# BUCKINGHAM TOWN COUNCIL

## INTERIM COUNCIL MEETING

## Planning application 17/00746/APP

**Amended Plans**

. Attenuation pond outlined in blue

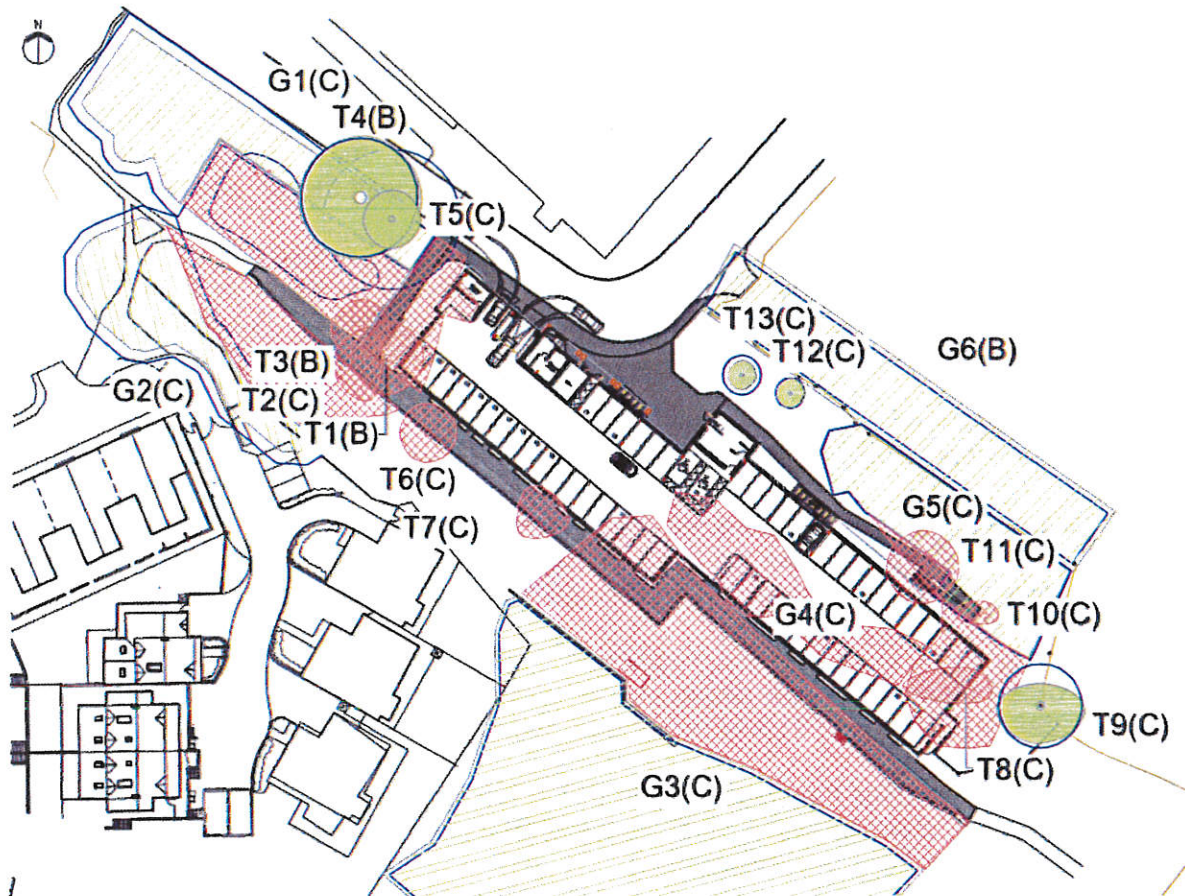
An attenuation basin is proposed in the woodland to the west of the car park, and this, together with the extension of the building to the east, will require the removal of a number of trees, many of which their report says are of poor quality due to neglect. The area is subject to a TPO (TP 5624, 1993). A number of new trees are included in the landscaping.

Protected Trees in red areas: T8 ash (T9 sycamore is close) and groups G1 (horsechestnuts, limes, sycamore, silver birch, willows and ash) & G2 (yews)

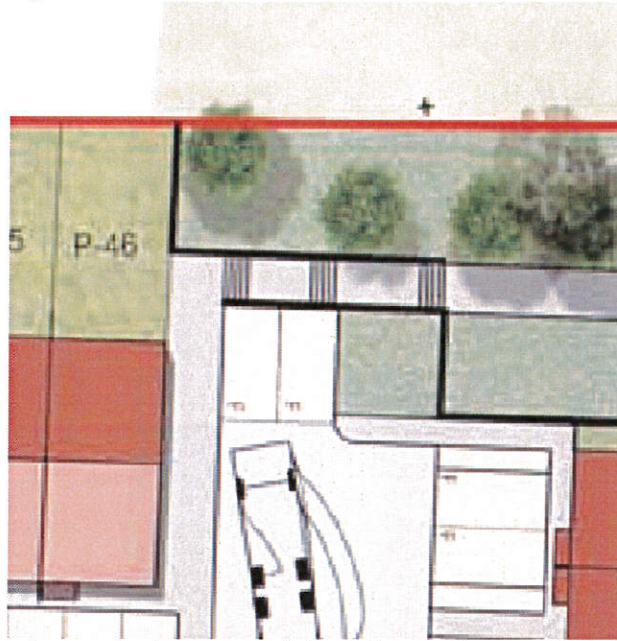
7. "8.0.8. Inclusive access benefits not only those with physical impairments but also benefits individuals with, sensory or learning impairments, older people, mental health system users/survivors, children, carers of young children, people with temporary impairments or simply encumbered with heavy luggage or shopping.  
8.0.9. Access will be inclusive with identified provision for a proportion of parking spaces to full mobility standards within the residential areas. The gradients of roads and footpaths and design of the public realm within the site will enable use by people in wheel chairs, those with impaired movement, or pushchairs."

A pity, then, that the pathway to the open space area and Riverside Walk (which gives access to the playground in Clarence Park) appears to involve three flights of steps between retaining walls (the heavy black lines)

and the Riverside Walk is also noted as a sustainable cycling route into town (para 9.1.3).

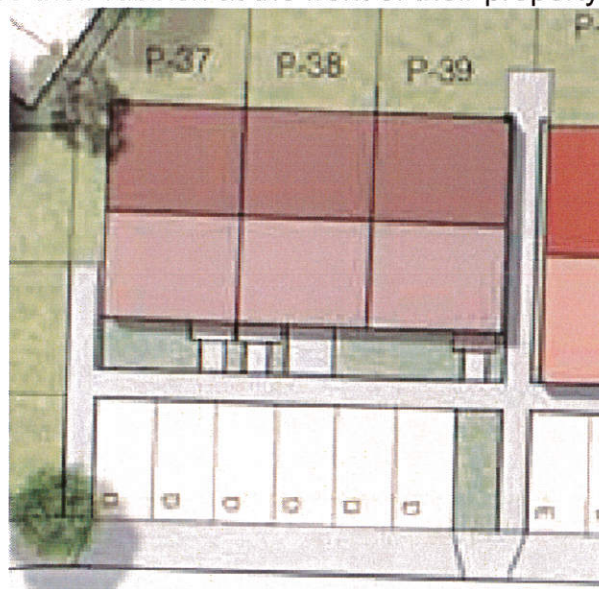
8. Members have commented that the difficulty of bringing bins out from the rear of the terraces might lead to their being stored at the house front, and this is referenced in the Planning Supporting Statement, p15:

5.11 Concerns were raised about the mid terraced properties potentially storing bins to the front of their properties due to the distance they would have to bring their bins from their back gardens. To address this issue bin storage areas can be provided to the fronts of these two properties.

However the front elevation drawing for plots 37-39 shows no such structure, and the plan below may just be showing bins kept at the front – this needs to be clarified especially as the DAS para 11.0.2 states “Occupants of private and affordable dwellings are to keep their rubbish in the rear of their property in allocated bins provided by the local authority. On bin collection day, occupants are to place their rubbish at the front of their property”.

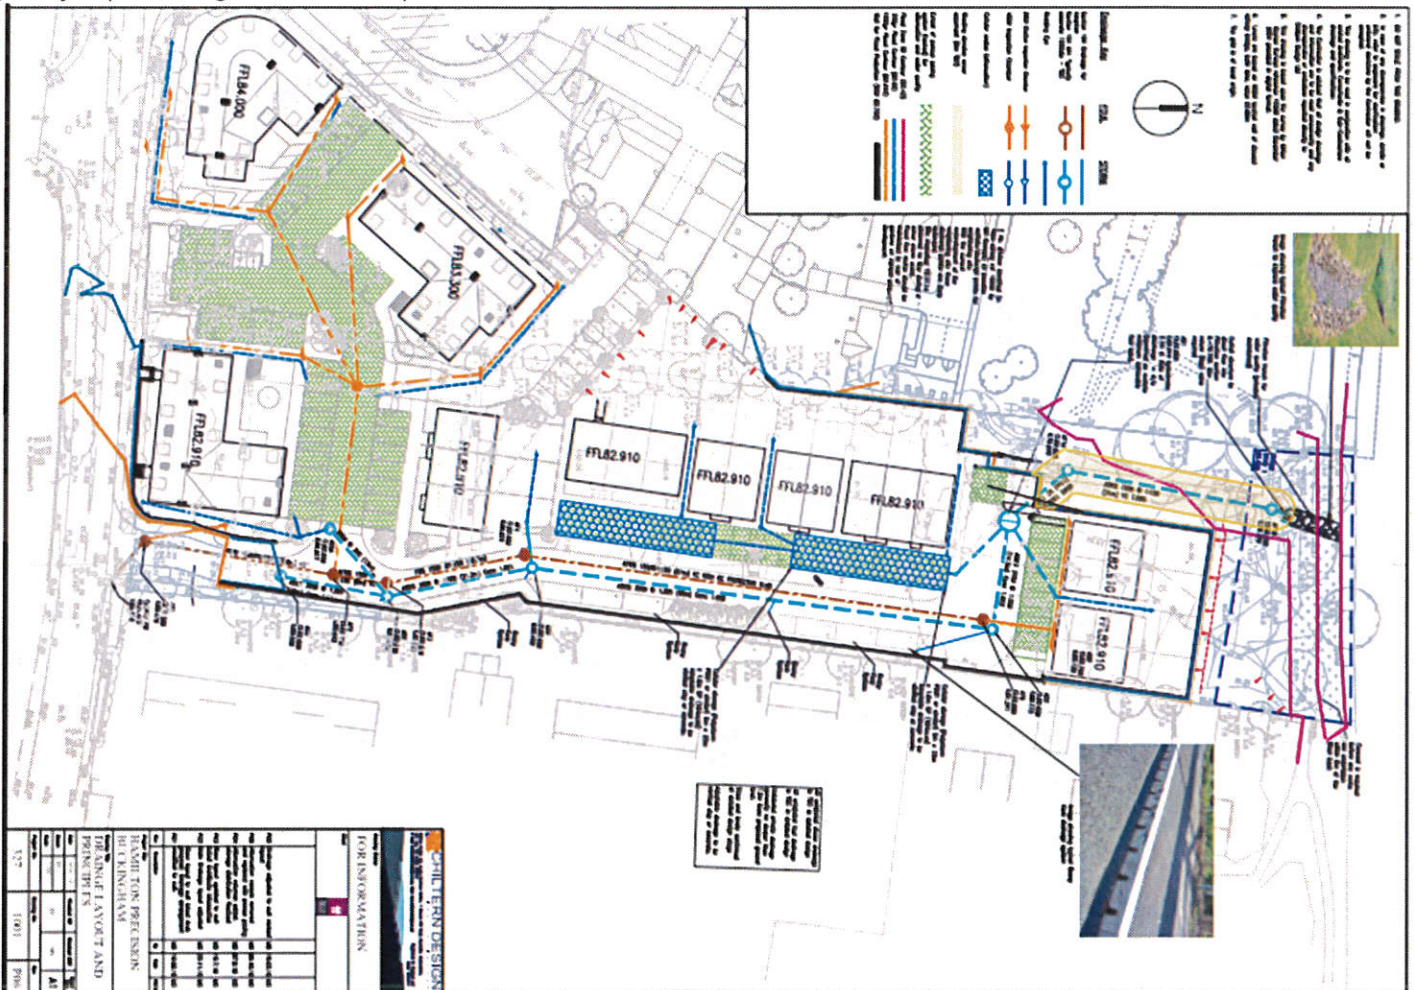
The D&A Statement, para 2.8.4, says “The need for pumping of foul drainage to existing sewers in Tingewick Road should be recognised in the layout of the site” and again in para 4.9.2. “The need for pumping of foul drainage to existing sewers into Tingewick Road should be recognised in the layout of the site, which will form part of the civils and drainage design prepared by Chiltern

Design.” but there is no evidence of provision in the amended plans. The D&A Statement is undated but has been submitted as part of the new plans under the cover of CMIA Architecture. The Flood Risk Assessment also says (p12)

“4.5.2 The lower northern portion of the site will require a foul pump to pump up to the proposed gravity portion of the foul network on site, before discharging to the public foul sewer system located on Tingewick Road.”
